AWC DATABASE CATALOG/ATLAS
CORRECTION FORM

Map: Iliamna C-7, C-8

Water Body Number: 324-10-10150-2163-3101
324-10-10150-2163-0010, 324-10-10150-2163

Nomination Number: 12-077

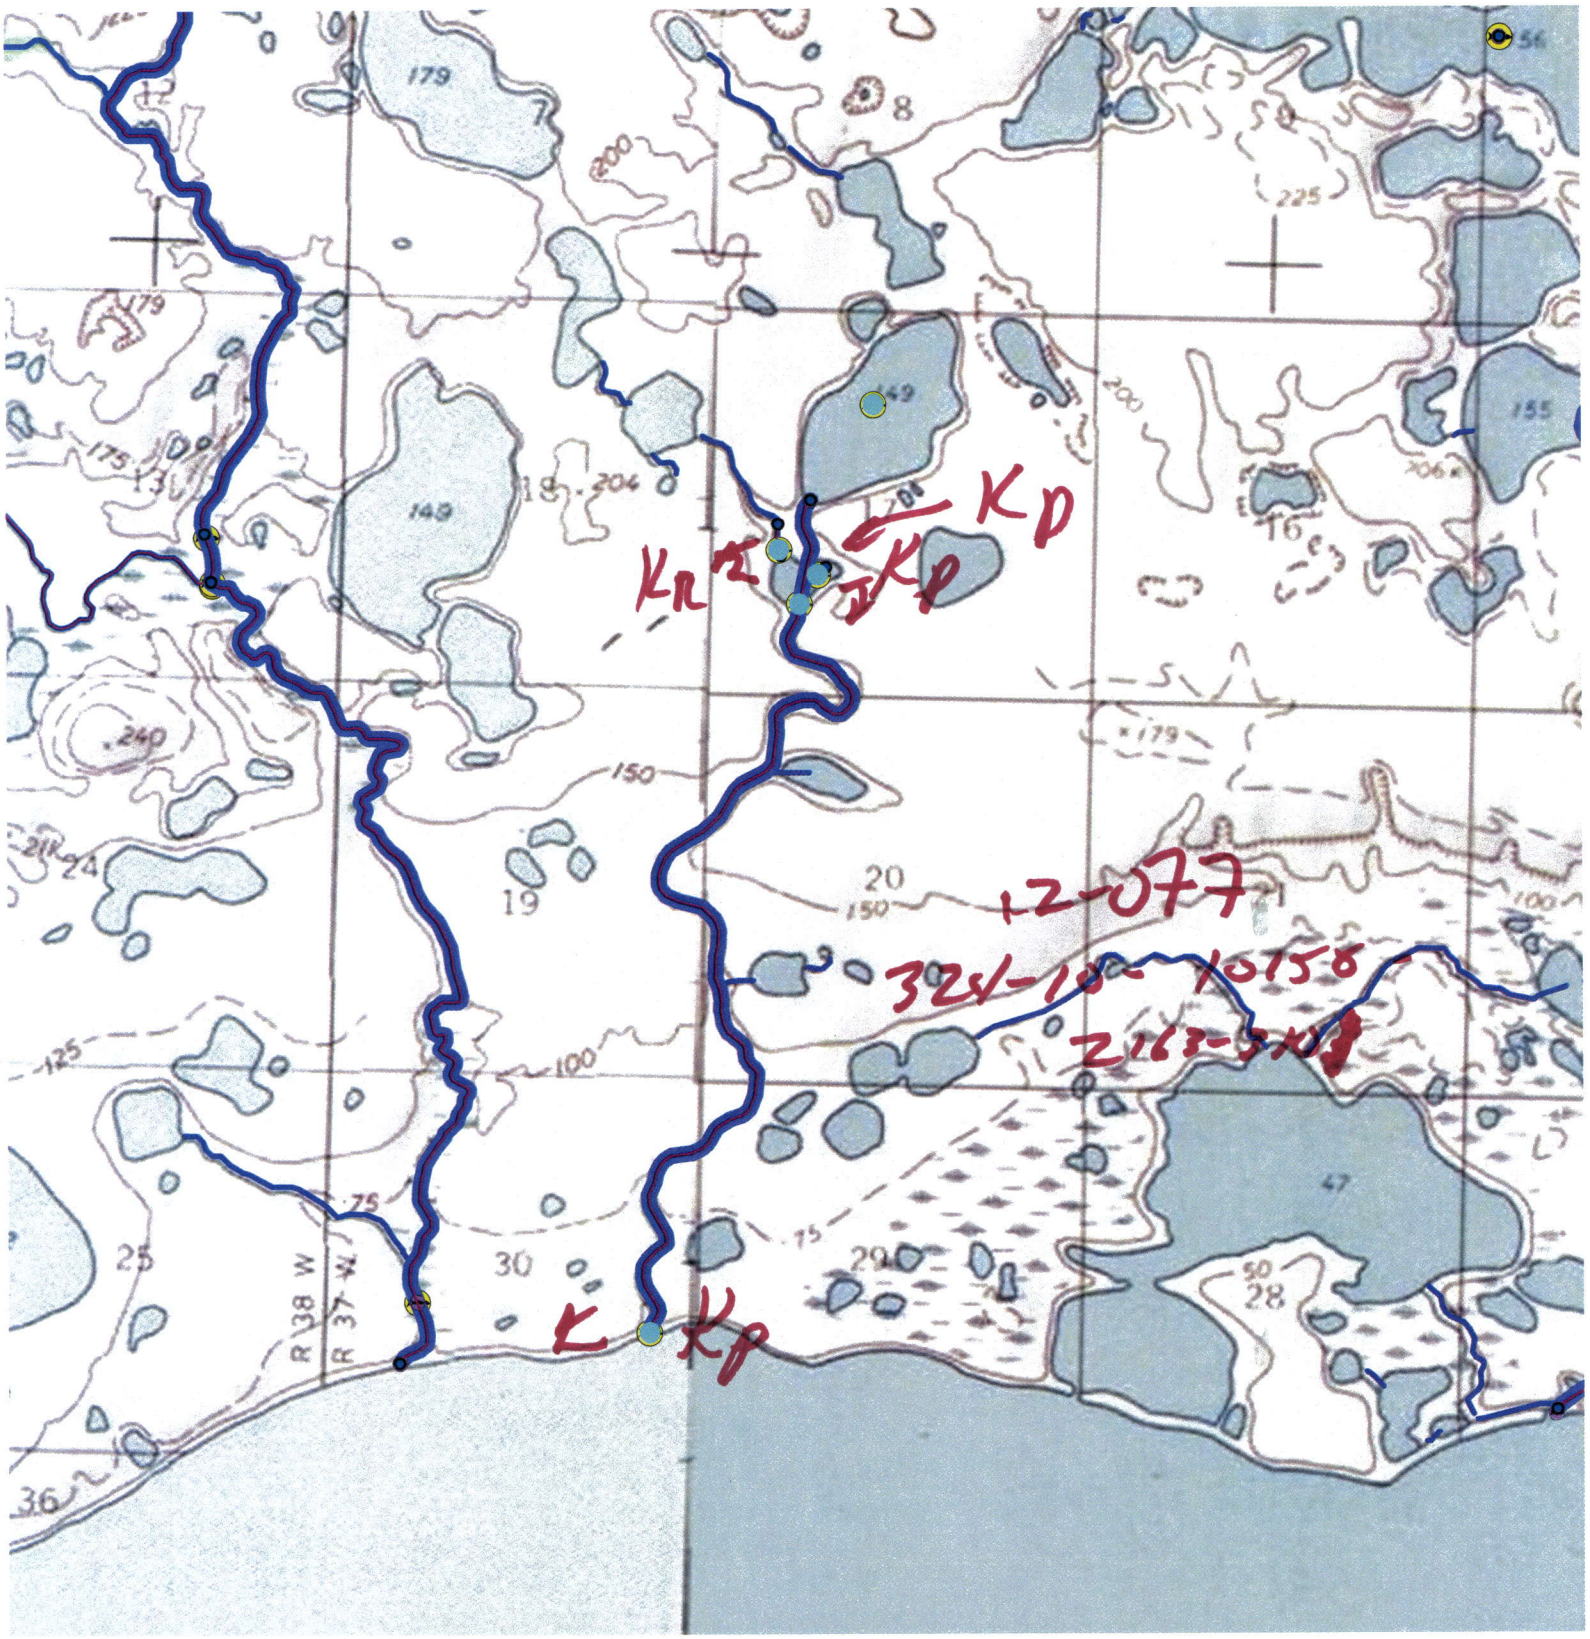
Add uppermost for Chinook salmon rearing ang

324-10-10150-2163-3101 @ 59.65467, -155.62269

Add Chinook salmon present to 324-10-10150-2163- (downstream)

and -0010

Iliamna Lake Tributaries

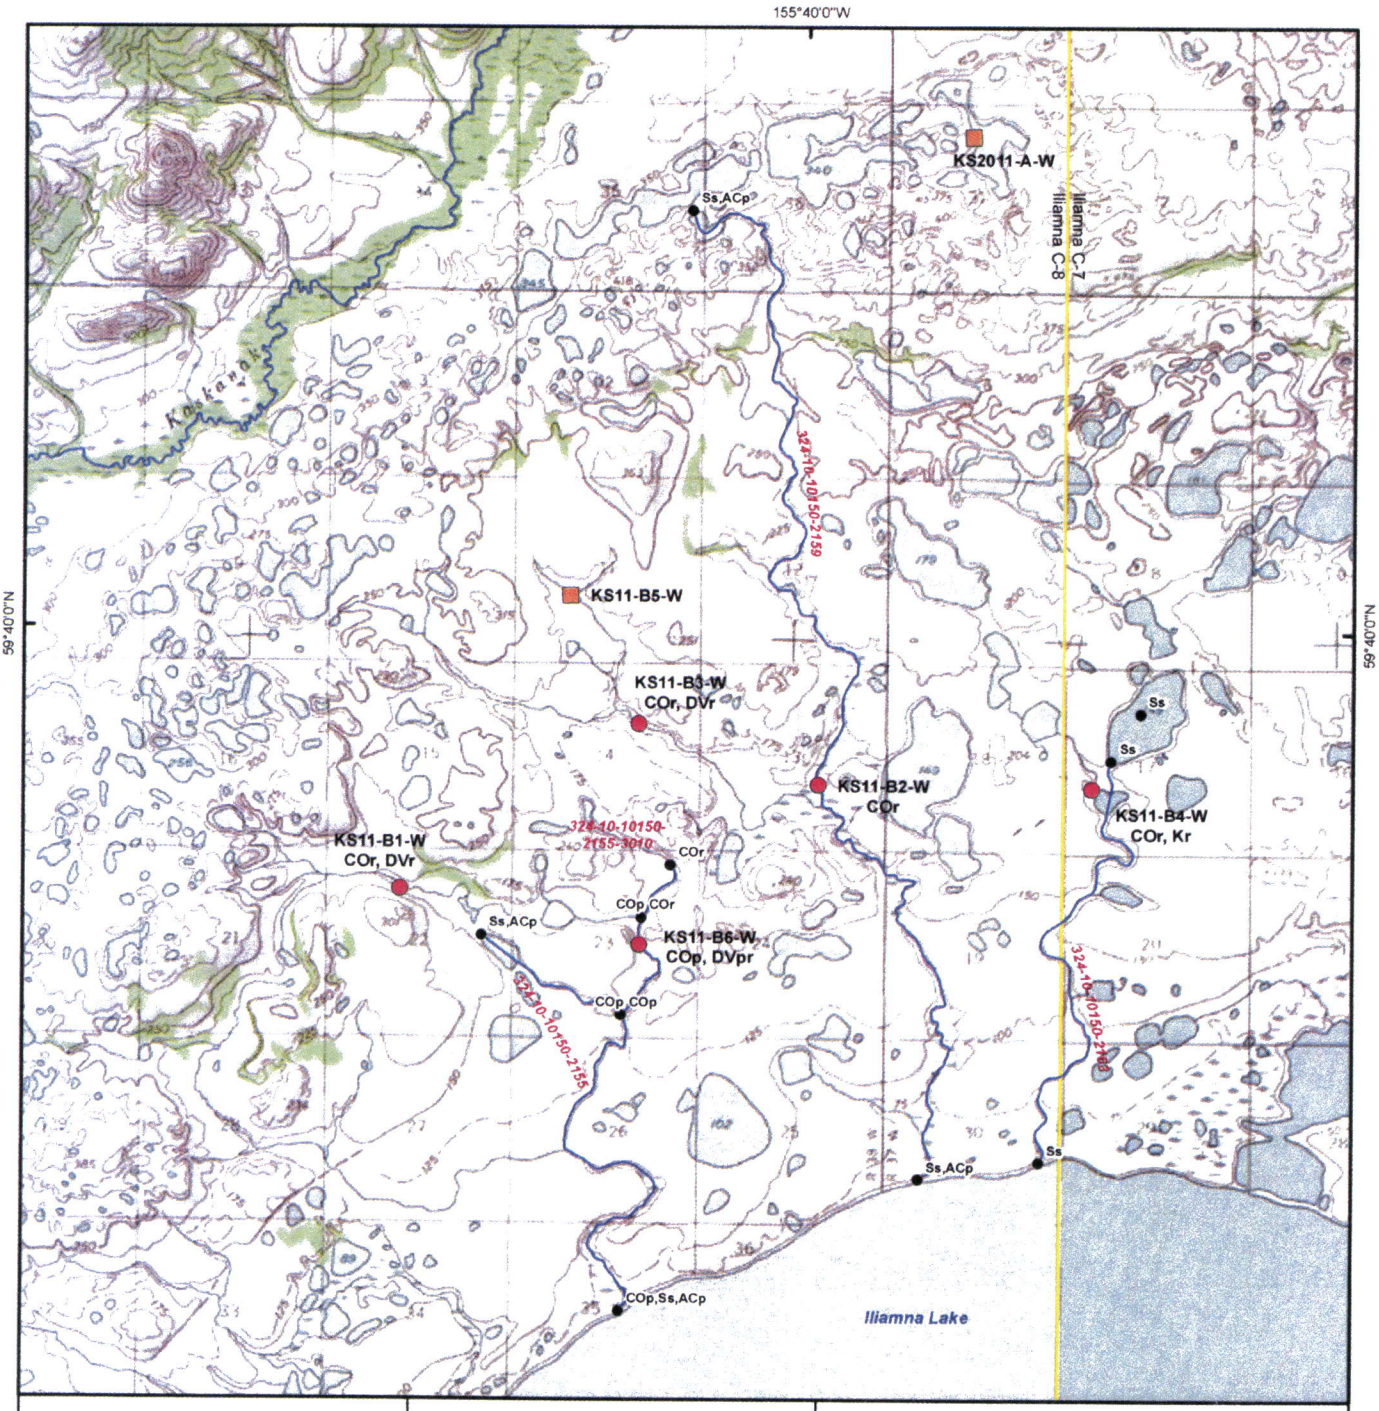
Change date ~~#~~ 324-10-10150-2163-0010 to -0020
Add new line 324-10-10150-2163-0010 w/ coho salmon present / sockeye salmon spawning

Add new stream (short) 324-10-10150-2163-3101 w/ coho salmon rearing

Add coho salmon present to 324-10-10150-2163

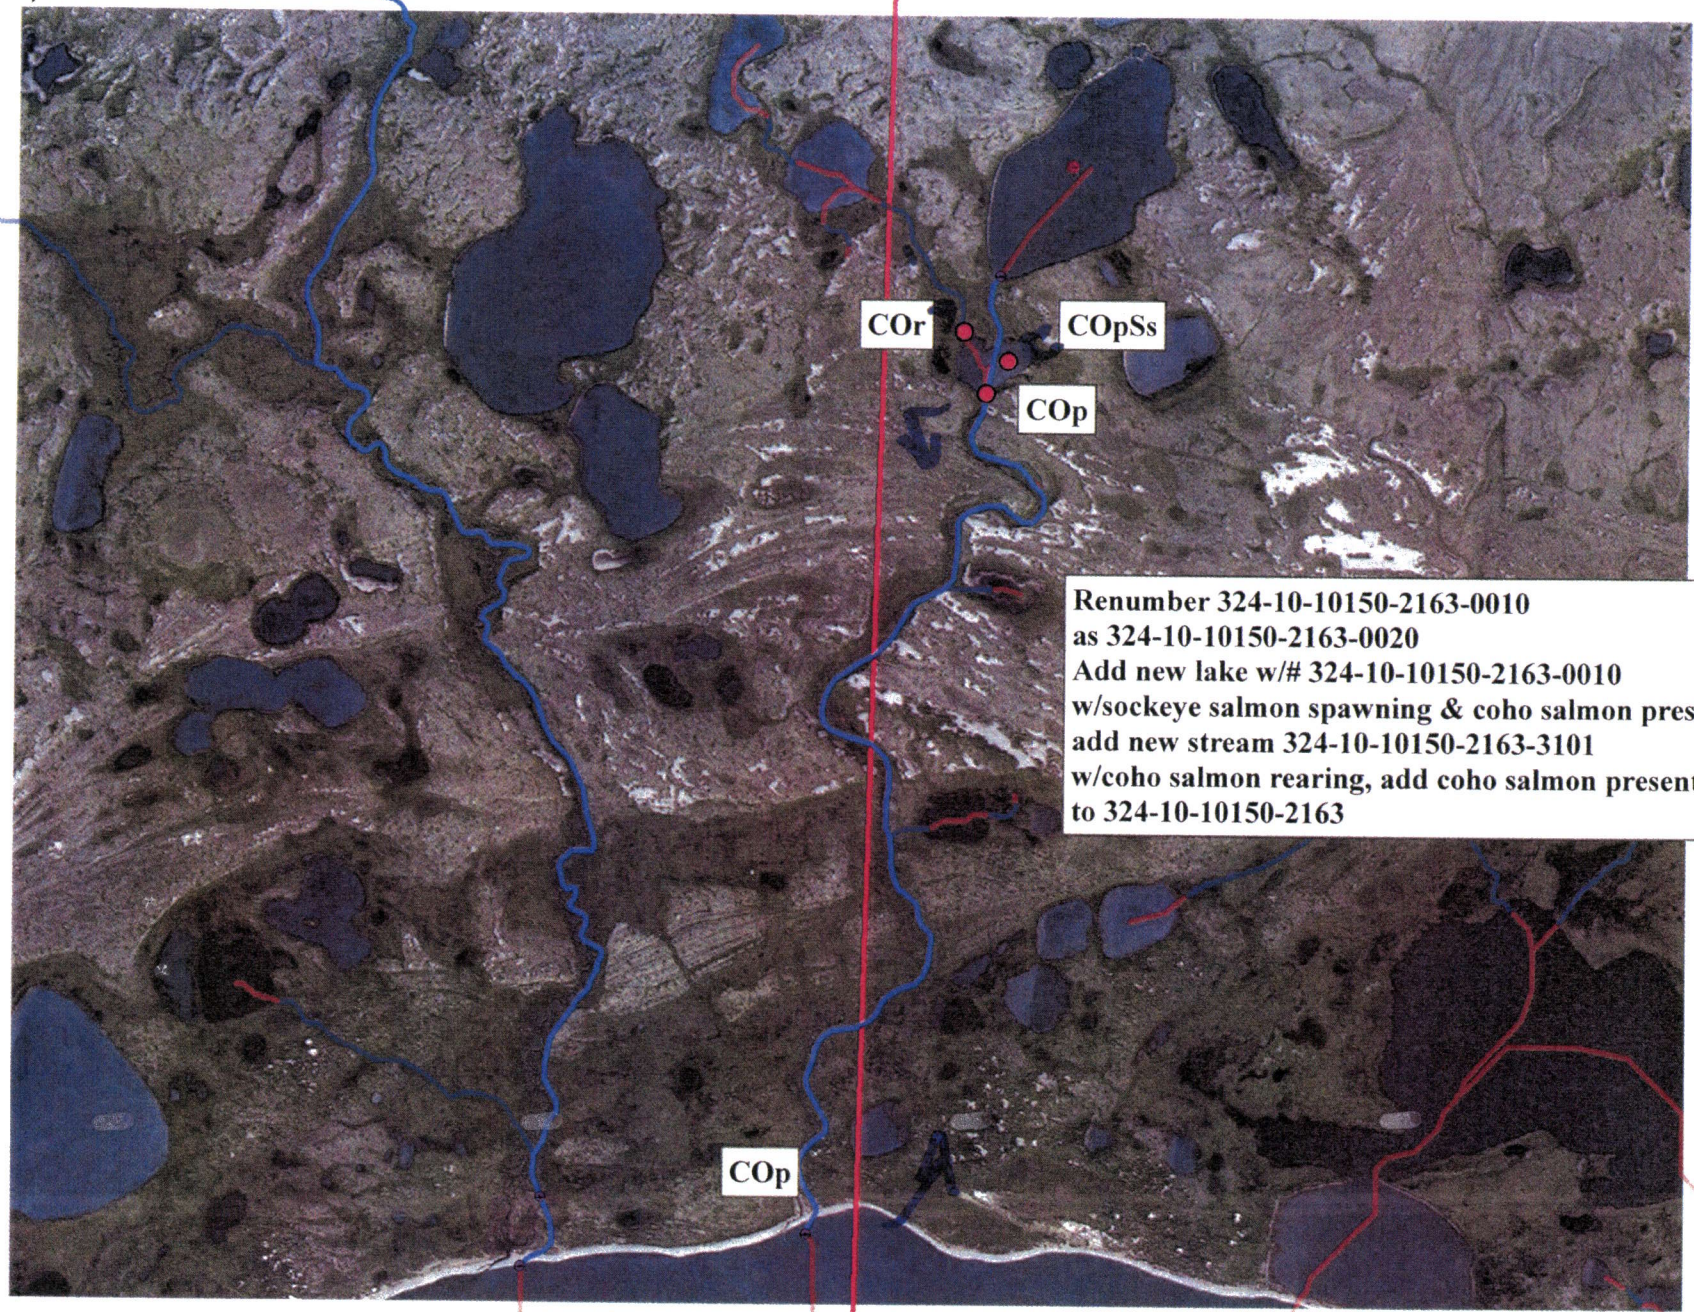
Renumber 324-10-10150-2163-0010
as 324-10-10150-2163-0020
Add new lake w/# 324-10-10150-2163-0010
w/sockeye salmon spawning & coho salmon present
add new stream 324-10-10150-2163-3101
w/coho salmon rearing, add coho salmon present
to 324-10-10150-2163
